# P802.1Qdt Text Contribution

Lily Lv (Huawei)

May-2022

Figure aaa-- MACsec enable PFC frame transmission

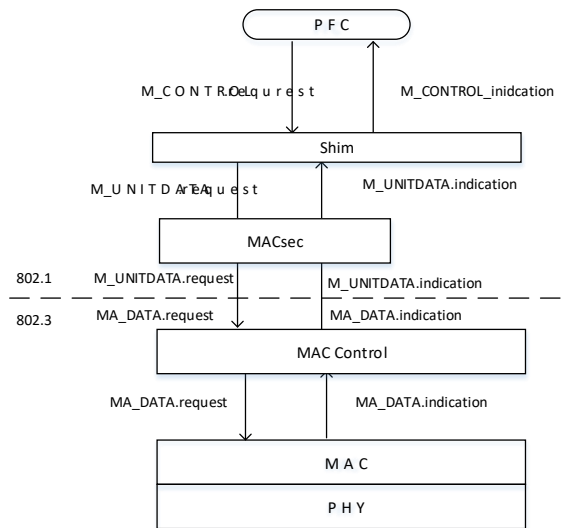
Is it ok to set service\_access\_point\_identifier and connection\_identifier to be NULL? How does CB consider those parameters?

Response: Those parameters are OK to be NULL.

- service\_access\_point\_identifier and connection\_identifier are used locally.

In 802.1AC(2016) 11.1 Service primitives and parameters, it says “Unlike the other parameters of the service primitives, the service\_access\_point\_identifier and connection\_identifier are not parameters of the peer-to-peer service. The values of the service\_access\_point\_identifier and connection\_identifier are purely **local to the system** within which a given service request or service indication occurs, and are not conveyed to the communicating peer system.”

- The shim and .1CB do not interfere with each other.

802.1CB functions are located on top of MACsec, working in parallel with shim layer.

.1CB does not handle service\_access\_point\_identifier, it only uses connection\_identifier to carry stream identification information as a subparameter. Stream identification information is generated by specific function modules like stream identification function and sequencing function. Such information could be converted to explicit field in packet when transmitting to remote system.

- PFC is a peer-to-peer service with fixed DMAC. PFC M\_CONTROL.request does not include service\_access\_point\_identifier and connection\_identifier information.
- Additionally, 802.11 parameter mapping shows us an example of setting the parameters to be NULL.
